Zamora Park Renovation Project

ADDENDUM #5

October 15, 2024

CITY OF EL MONTE
DEPARTMENT OF PUBLIC WORKS
ENGINEERING DIVISION
LIGHTING AND POWER PLAN
ZAMORA PARK

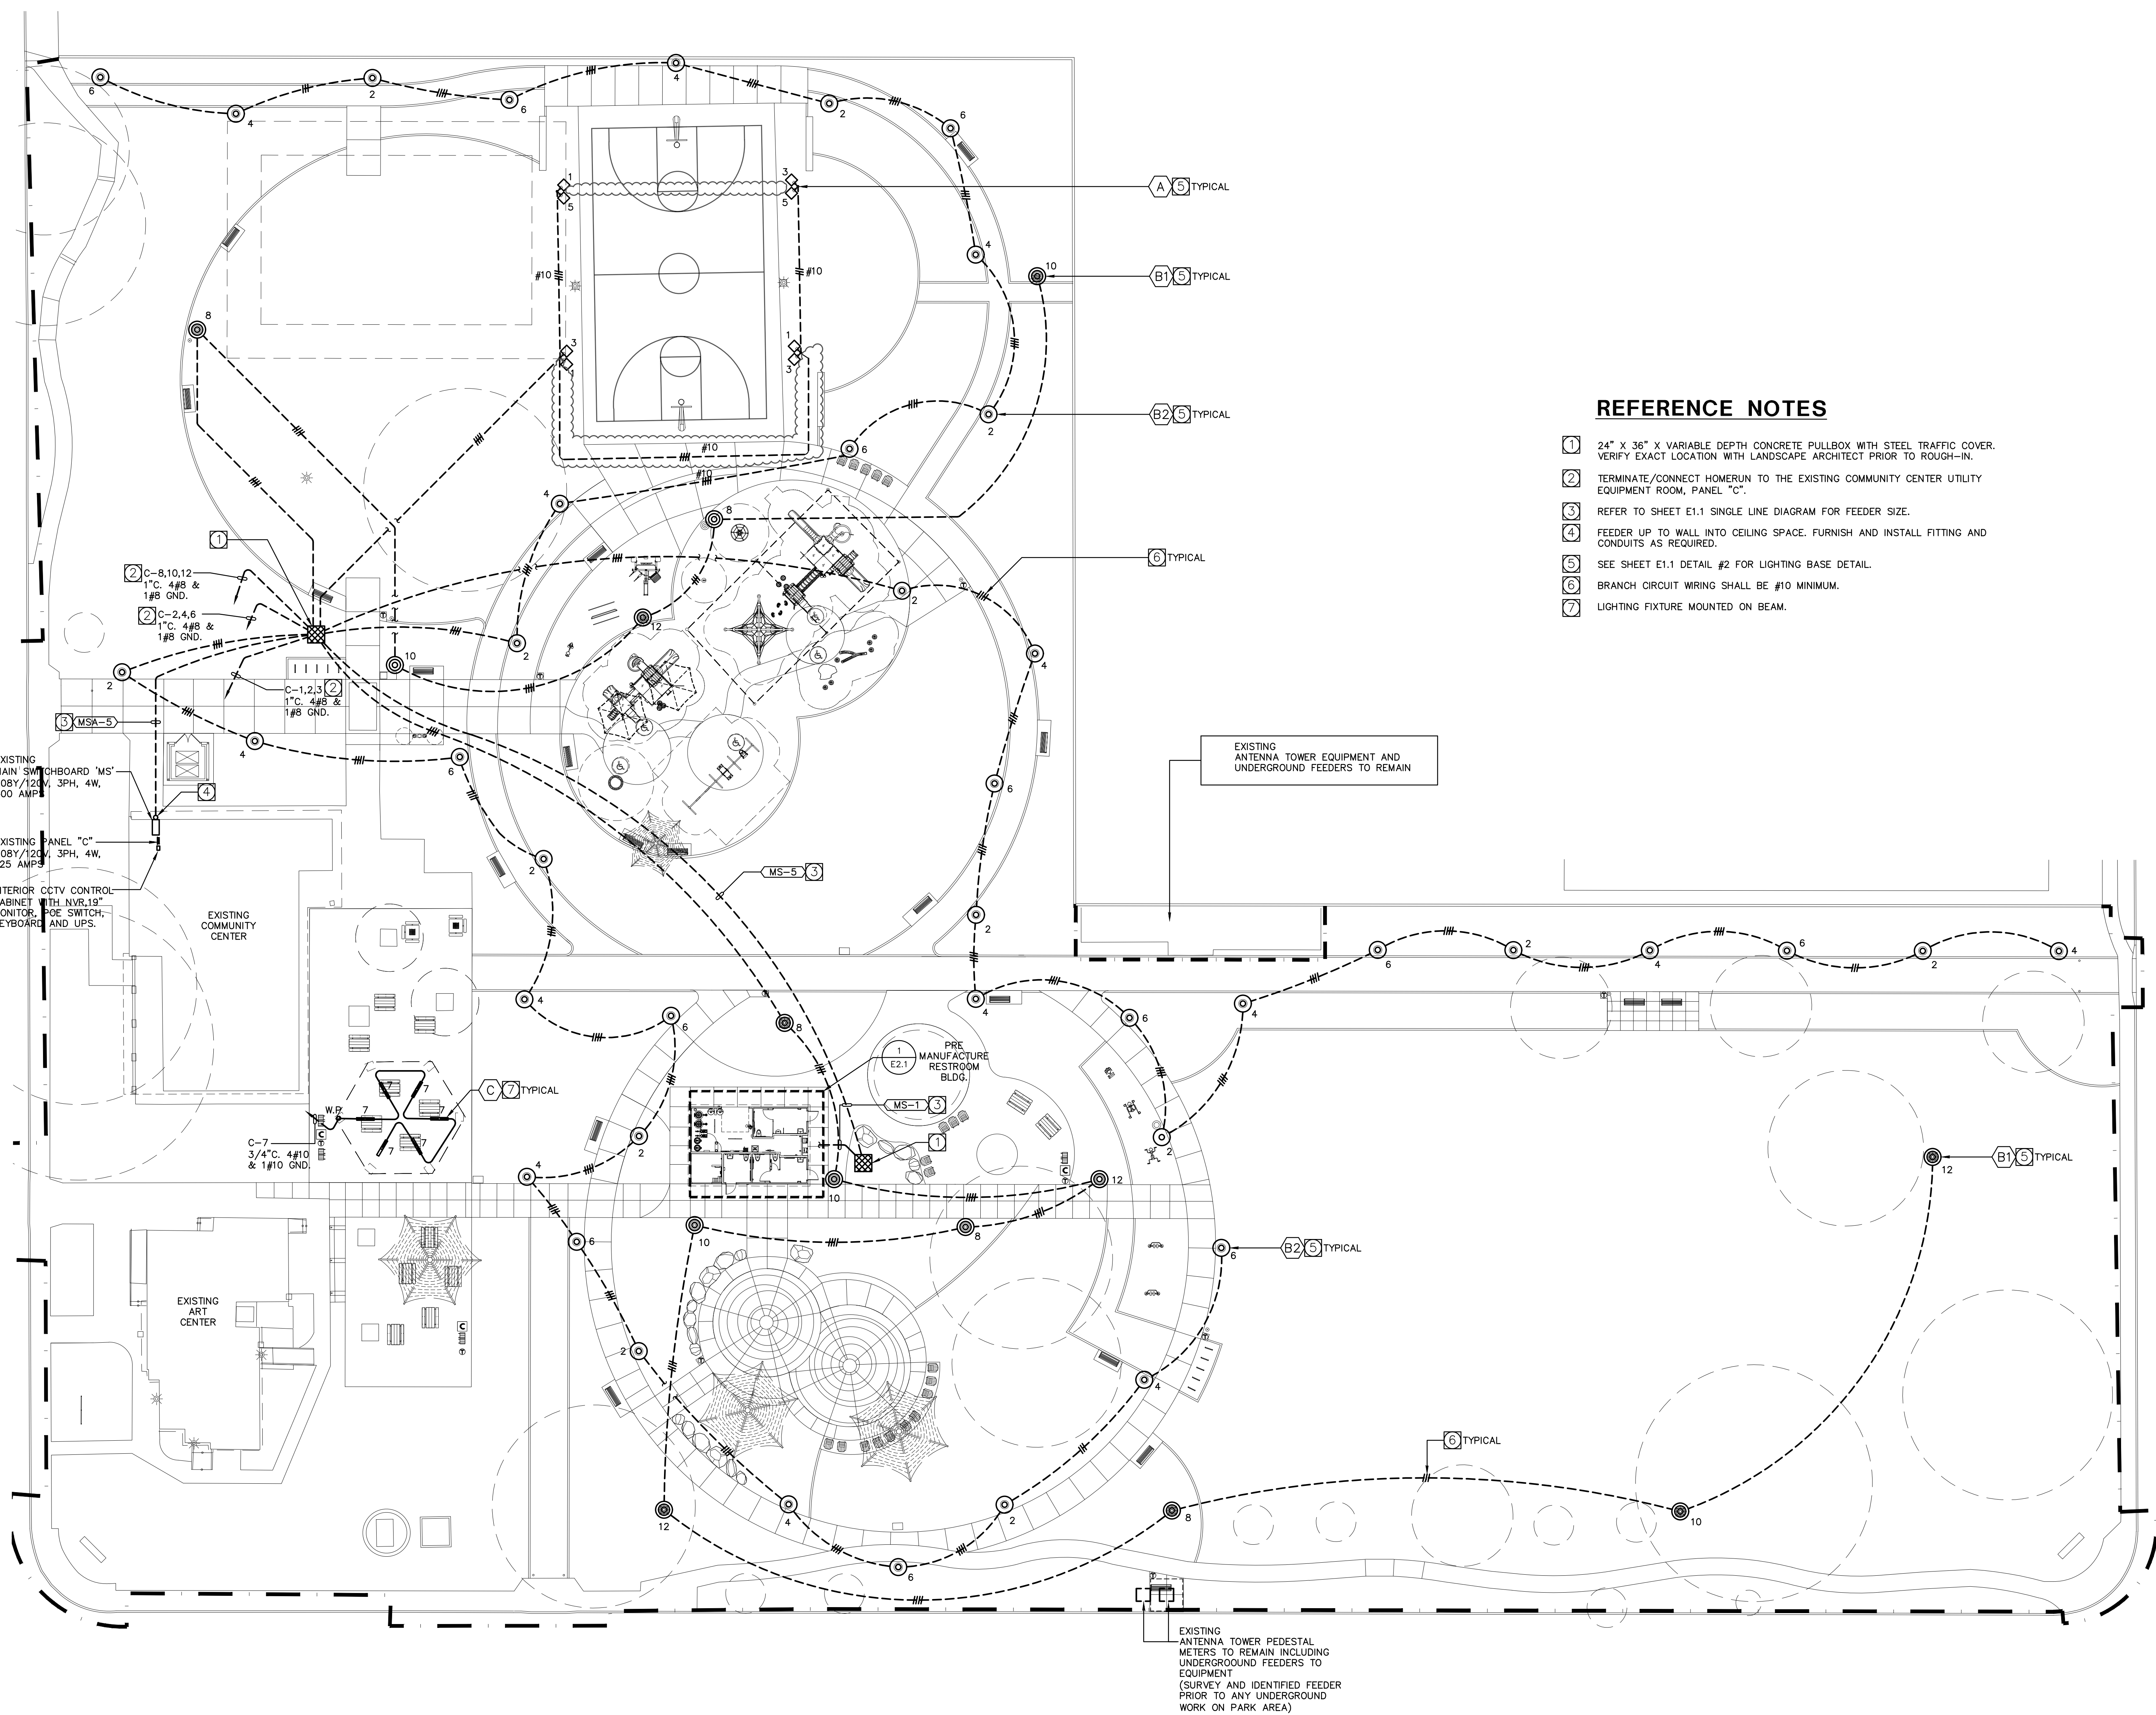
1. Revised E2.0 – Lighting and Power Plan, appended to this Addendum.
